United States Patent and Trademark Office

APPLICATION NO.	FILN	NG DATE	FIRST NAMED INVENTOR	ATTORNEY DOCKET NO.	CONFIRMATION NO.		
10/674,623 09/30/2003		30/2003	Bobbye Kaye Whitenton Baylis	2002P16242US01;60,427-605 4194			
24500	7590	12/02/2005		EXAMI	NER		
SIEMENS	CORPORA	GARCIA, ERNESTO					
INTELLECTUAL PROPERTY LAW DEPARTMENT							
170 WOOD .	AVENUE S	OUTH	ART UNIT	PAPER NUMBER			
ISELIN, NJ	08830		3679

DETAILED ACTION

Lohr, 6,267,093

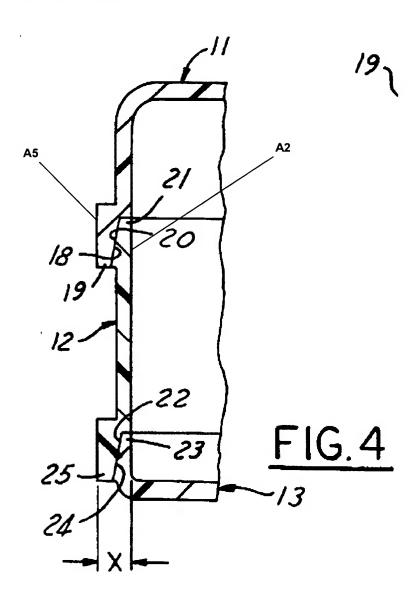
Claims 1, 2, and 5 are rejected under 35 U.S.C. 102(b) as being anticipated by Lohr, 6,267,093.

Regarding claim 1, Lohr discloses, in Figure 4, a laser weld comprising a first component portion 11 and a second component portion 12. The first component portion 11 defines a first laser weld surface A2 and includes a first taper surface 18 opposite from the first laser weld surface A2. The second component portion 12 defines a second laser weld surface A5 and includes a second taper surface 20

opposite from the second laser weld surface **A5**. The first taper surface **18** and the second taper surface **20** cooperate with each other.

Regarding claim 2, the first component portion 11 comprises an upper shell; the second component portion 12 comprises a lower shell. The upper shell 11 and the lower shell 12 together form an air induction component.

Regarding claim 5, the first taper surface or the second taper surface defines a taper angle of at least thirty degrees.
